Report of the Head of Development Management and Building Control Committee Report – Application Report

78464/APP/2024/3196

Site Address: **Dyson Drive, Uxbridge, UB10 0GJ**

Proposal: **The creation of 9no. off-street parking spaces and planting of 3no. new trees.**

Figure 3: Proposed Plan (please note – larger version of plan can be found in the Committee Plan Pack)

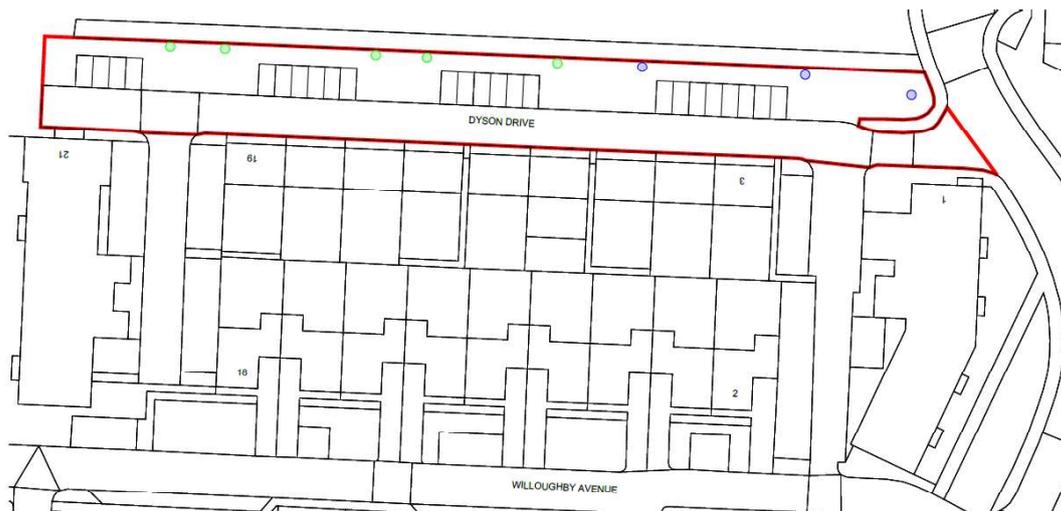
- 7.6 The proposed 9no. parking spaces would be allocated to homeowners on Dyson Drive. The Design and Access Statement suggests that the proposal would result in the removal of cars parking along the road and would improve the openness within the street scene. Drawing FLU.CP.02 titled 'Proposed Location and Site Plans' shows the proposed layout, which provides the additional car parking spaces adjacent to the existing rows of car parking spaces. Whilst the proposed arrangement would provide additional allocated parking spaces, due to the lack of parking controls on Dyson Drive, it is considered that the proposal would not resolve the existing informal parallel parking that currently occurs on the shared surface at Dyson Drive. It is therefore considered that the proposal could exacerbate the level of car parking and congestion on Dyson Drive.

- 7.7 As noted by the Highway Authority, the highway is a shared surface and the increase in formal parking spaces would increase the volume of traffic using Dyson Drive. The uplift in traffic volume would increase the potential for conflict with pedestrians and cyclists, which raises concerns on highway safety grounds. The proposal would fail to accord with the published NPPF Chapter 9 Promoting Sustainable Transport, the London Plan (2021) and London Borough of Hillingdon Local Plan Part 2 - Development Management Policies (2020).

- 7.11 The proposal would require the removal of green spaces alongside the existing parking bays to accommodate the new parking spaces. The new parking spaces are proposed to be surfaced with 'grasscrete'. Whilst an effort has been made to retain a green visual aspect, the proposed use of grasscrete is not considered to be a suitable or effective solution to offset the loss of green space.

- 7.12 The additional car parking spaces, the loss of green space, the proposed surfacing and the resulting proliferation of parked cars would be detrimental to the character of the area and would detract from the visual quality and usability of the landscaped pedestrian link, which is seen as an important part of the estate. The level of harm identified, is however on balance, not considered to be significant to warrant a separate reason for refusal.

- 7.14 There are no direct issues that are purely related to accessibility matters. However, it is worth noting that the proposed layout shows the car parking to be accessed via the shared surface, increasing the number of vehicle movements and therefore the potential risks for pedestrians and cyclists. This raises concerns on highway safety grounds, but is not considered to be a separate reason for refusal.
